# Punta Gorda

## CITY OF PUNTA GORDA ADA TRANSITION PLAN FINAL REPORT Harborwalk East

October 4, 2017

**Harborwalk East Ramp Violations**

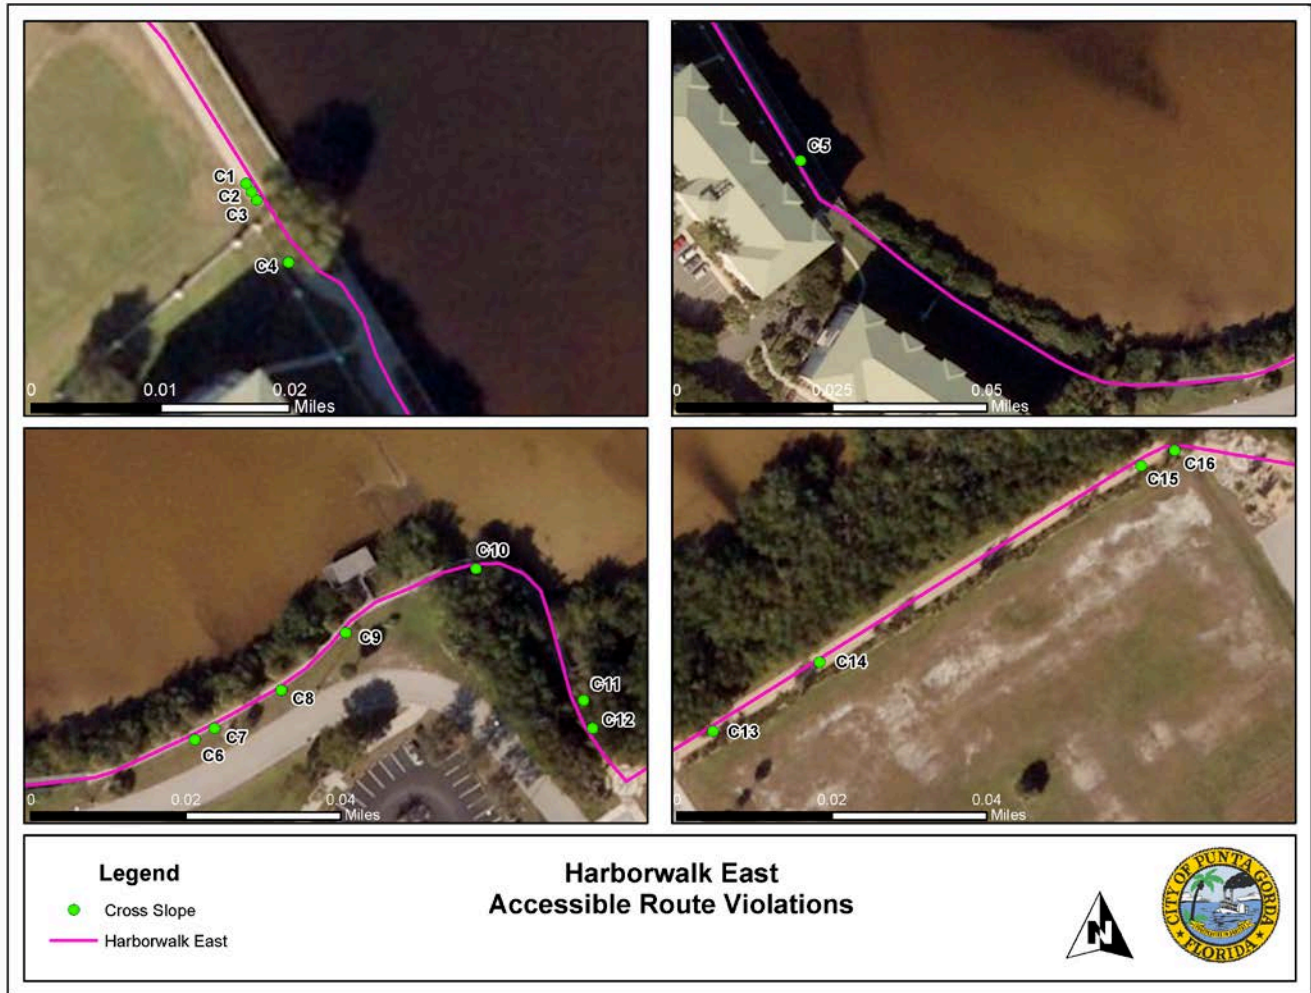
Map Item	Description & Recommendation	Photo
<p><b>M1</b></p>	<p>There is a 1.5” lip at the entrance to the walkway.</p> <p>Resurface the cement/wood transition to minimize the lip, per <b>ADAAG 303</b>.</p>	
<p><b>M2</b></p>	<p>Tree branches extend below 80” into the accessible route.</p> <p>Trim and maintain the foliage so the accessible route is clear of obstructions, per <b>ADAAG 307</b>.</p>	
<p><b>M3</b></p>	<p>There is a 1.5” lip at the entrance to the walkway.</p> <p>Resurface the cement/wood transition to minimize the lip, per <b>ADAAG 303</b>.</p>

Map Item	Description & Recommendation	Photo
<p><b>M4</b></p>	<p>Tree branches extend below 80" into the accessible route.</p> <p>Trim and maintain the foliage so the accessible route is clear of obstructions, per <b>ADAAG 307</b>.</p>	
<p><b>M5</b></p>	<p>A detectable warning is not required at this location and may be confusing to a person with a vision impairment.</p> <p>Remove the detectable warning.</p>	
<p><b>M6</b></p>	<p>Tree branches extend below 80" into the accessible route.</p> <p>Trim and maintain the foliage so the accessible route is clear of obstructions, per <b>ADAAG 307</b>.</p>

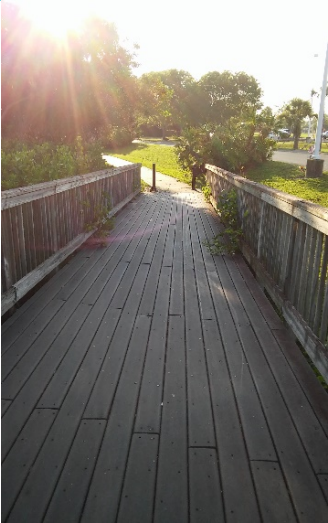
Map Item	Description & Recommendation	Photo
<p><b>R1</b></p>	<p>The running slope is greater than 5% for about 20" in length and there are no handrails.</p> <p>Either minimize the running slope to be no greater than 5% or add handrails and landing areas per <b>ADAAG 405.8</b> and <b>ADAAG 405.7</b>.</p>	
<p><b>R2</b></p>	<p>The running slope is 6%, and there are no handrails.</p> <p>Either minimize the running slope to be no greater than 5% or add handrails and landing areas per <b>ADAAG 405.8</b> and <b>ADAAG 405.7</b>.</p>	
<p><b>R3</b></p>	<p>The running slope is 5.5%, and there are no handrails.</p> <p>Either minimize the running slope to be no greater than 5% or add handrails and landing areas per <b>ADAAG 405.8</b> and <b>ADAAG 405.7</b>.</p>
